Access Compliance Report

(Curb Ramps)

Intersection ID: 20285	Main Street: BELKNAP_RD	Cross Street: CORTELYOU_RD	Location: NW
ADA ID: 87728EAEFF4E	Ramp Type: PerpDiag	Initial Pass/Fail: Fail	Overall Compliance: No
Codes/Mitigation Info/Possible Solution		Field Measurements/Component Compliance	
Severity Score: 22.5

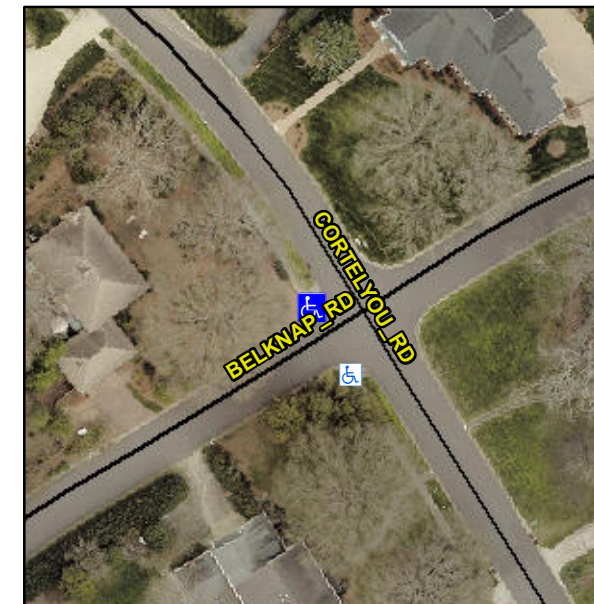
Not Found, R304.5.1, R304.2.2, R304.5.3

Compliance	Description	Data	Compliance	Description	Data
N/A	Ramp Length (in)	98.0	No	Ramp Slope (%)	10.2
No	Ramp Width (in)	43.0	No	Ramp XSlope (%)	2.7
N/A	Flare Type LT	N/A	N/A	Flare Type RT	N/A
N/A	Flare Slope LT (%)	N/A	N/A	Flare Slope RT (%)	N/A
N/A	Flare Traversable LT?	N/A	N/A	Flare Traversable RT?	N/A
N/A	Landing Length (in)	N/A	N/A	DWS Provided?	N/A
N/A	Landing Width (in)	N/A	N/A	DWS Contrast?	N/A
N/A	Landing Slope (%)	N/A	N/A	DWS Length (in)	N/A
N/A	Landing X Slope (%)	N/A	N/A	DWS Full Width?	N/A
N/A	Landing Curb? (Y/N)	N/A	N/A	DWS Offset (in)	N/A
N/A	Shared Landing?	N/A			
N/A	Gutter Ponding?	N/A	N/A	Gutter Slope (%)	N/A
N/A	Gutter Lip Ht (in)	2.0	N/A	Gutter X Slope (%)	N/A
N/A	Painted X Walk1?	No	N/A	Painted X Walk2?	No
	X Walk 1 Direction	To SE		X Walk 2 Direction	To NE
N/A	X Walk 1 Width (in)	N/A	N/A	X Walk 2 Width (in)	N/A
	X Walk 1 Slope (%)	0.5		X Walk 2 Slope (%)	4.7
	X Walk 1 X Slope (%)	4.4		X Walk 2 X Slope (%)	6.0

Remove & Replace Curb Ramp With Two New Directional Ramps or Equivalent.
